Memo no: WBSEDCL/IT&C/114.00(RDSS)/ 2838

Date: 29.04.2024

**Corrigendum and clarifications for DC/DRC infrastructure upgradation
under IT/IT-OT implementation at**

E-Tender No. WBSEDCL/IT&C/114.00(RDSS)/2527 Dated: 28.02.2024

Sheet - Diagram

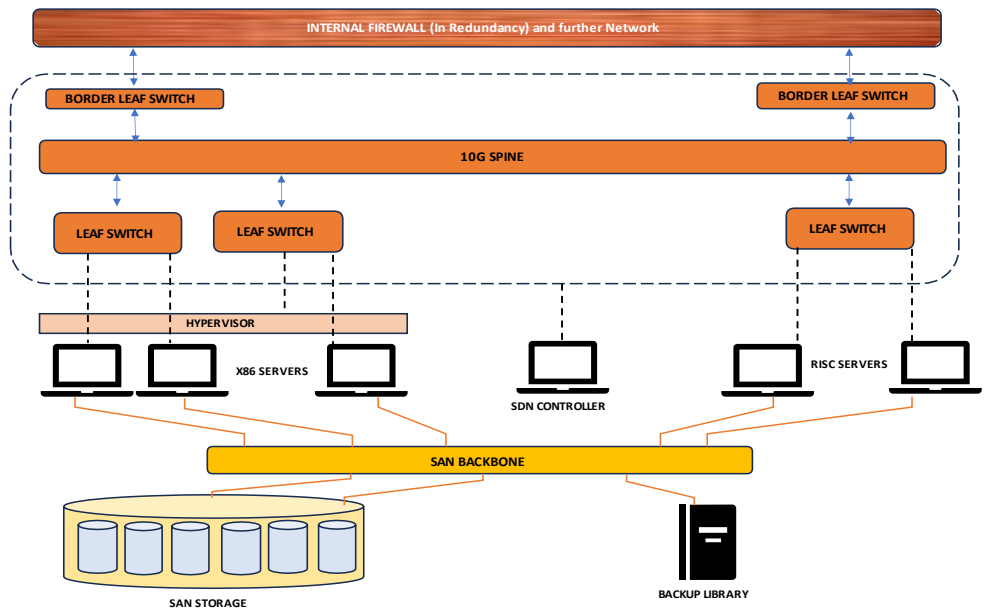
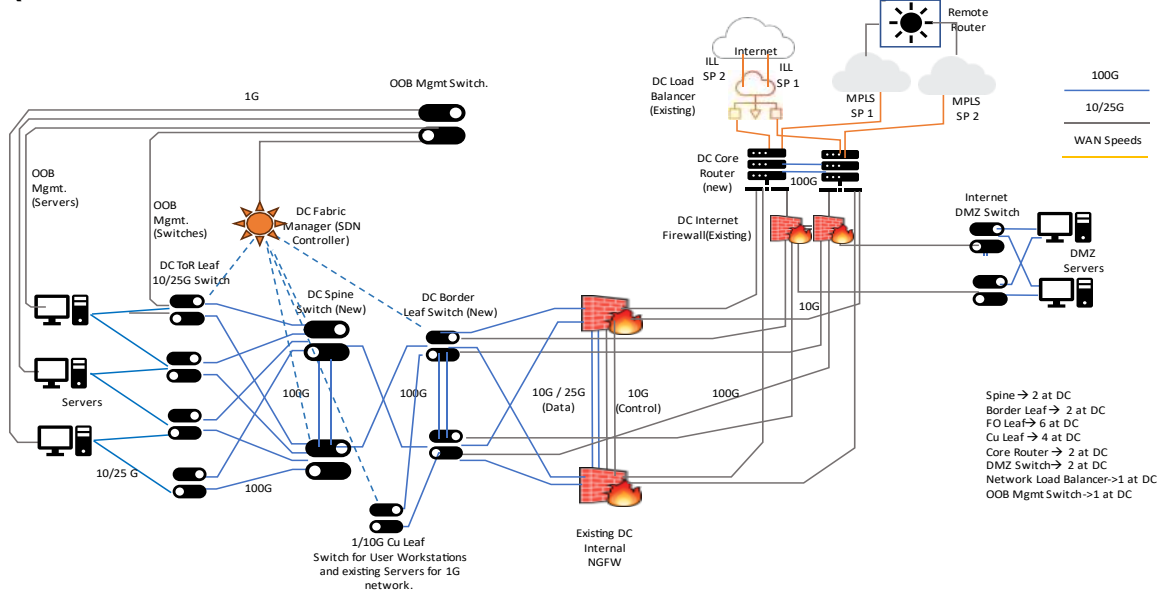
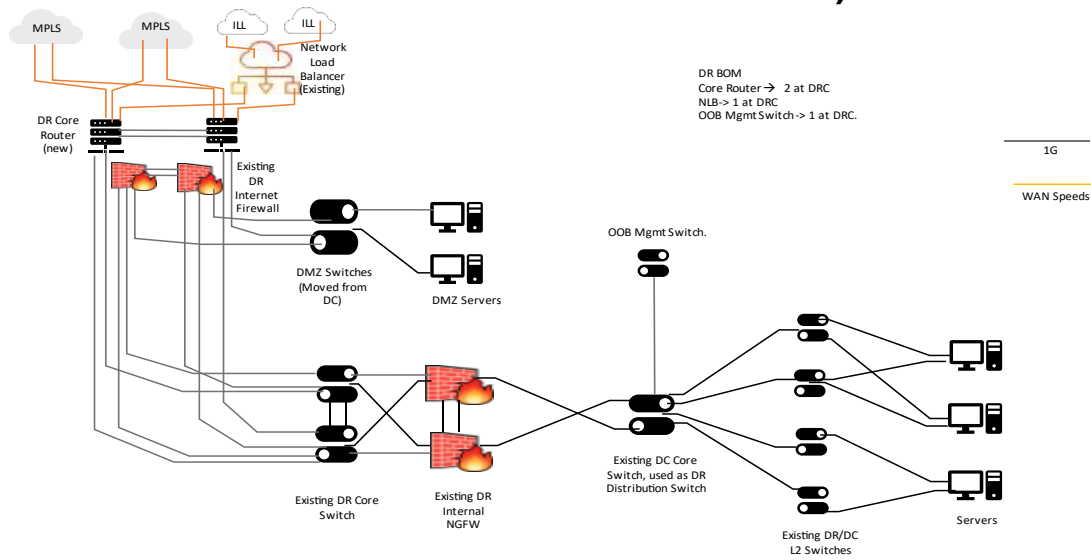
6.2.2	Indicative High-Level architecture	163		Architecture diagram indicates both hyper-converged infrastructure along with mention of private cloud. Clarity requested in exact scope.	Tender BQ does not list any HCI or private cloud. Pls help clarify the scope of bidder with respect to HCI as well as private cloud in clear and unambiguous terms.	Please see the amendment and refer the sheet-Diagrams

6.2.2.2	Drawing of the Indicative upgraded Network.	164	The DRC network would not be upgraded to SDN and would continue to be in the conventional Network System connected with the existing 1G DRC Network	Pls clarify SDN implementation scope across DC & DRC.	DC is being asked with SDN whereas DRC asked to remain with conventional network.	As per RFP and subsequent Amendment. DC to upgraded from 1G to 10G as an SDN. DRC to remain in 1G under conventional Network.
